**GPU Nuclear Corporation**  
Post Office Box 480  
Route 441 South  
Middletown, Pennsylvania 17057-0191  
717 944-7621  
TELEX 84-2386  
Writer's Direct Dial Number:  
(717) 948-8461

December 31, 1987  
4410-87-L-0192/0331P

Three Mile Island Nuclear Station, Unit 2 (TMI-2)  
Operating License No. DPR-73  
Docket No. 50-320  
Handling of Core Bore Equipment Above the Defueling Work Platform

The purpose of this letter is to request NRC approval to modify the lift height limit for installation of the core bore machine on the Defueling Work Platform.

INSTALLATION

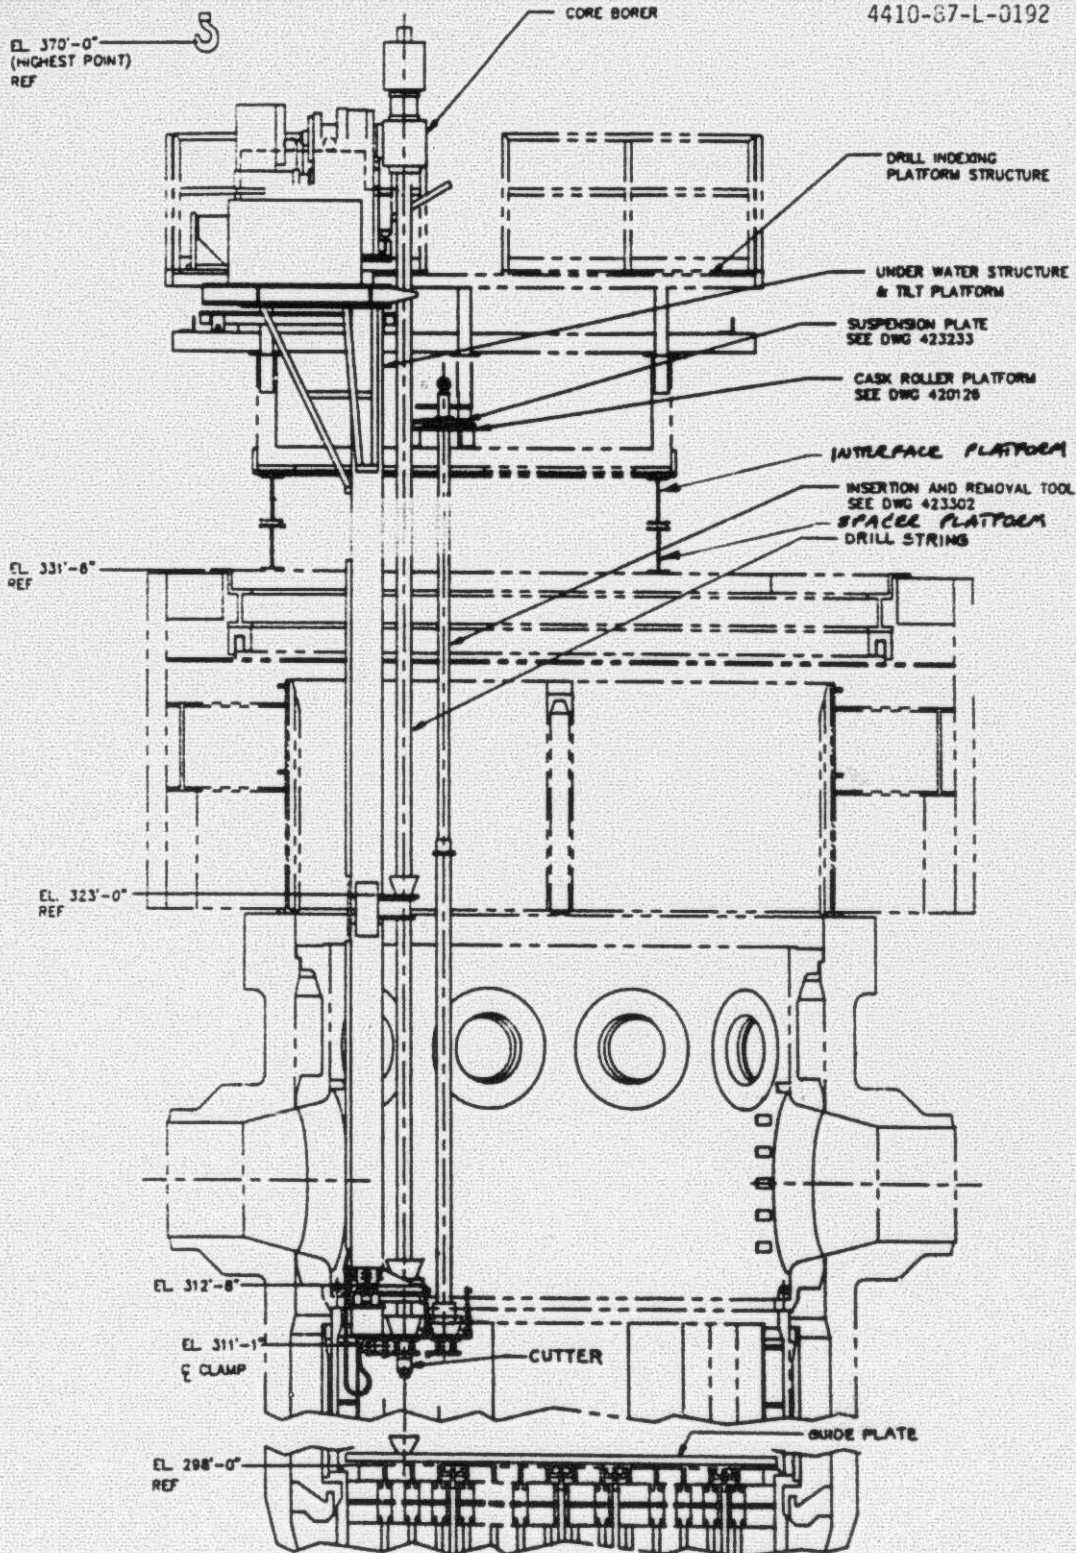
However, due to the incorporation of an underwater tool changer, an 18" high spacer platform will be installed between the work platform and the interface platform (see attached sketch). Note, the footprint for the spacer platform is identical to the interface platform. Thus, the lift height limit must be raised 18" to the 340'-6" elevation to facilitate installation and removal of the core bore machine.

The travel distance that the load will fall to the interface platform for a postulated drop remains the same as previously analyzed. Therefore, the impact energy of 409,000 in-lbs. that the falling object would develop if dropped remains the same as previously analyzed. The impact energy of 559,000 in-lbs. transmitted to the portion of the work platform along the load path over to the interface platform is also still within the allowable limit of 780,000 in-lbs. previously analyzed for the Core Stratification Sample Acquisition SER.

The installation and removal procedure for the drill rig and underwater support structure will specify the shortest load path to further reduce the potential consequences of a postulated load drop.
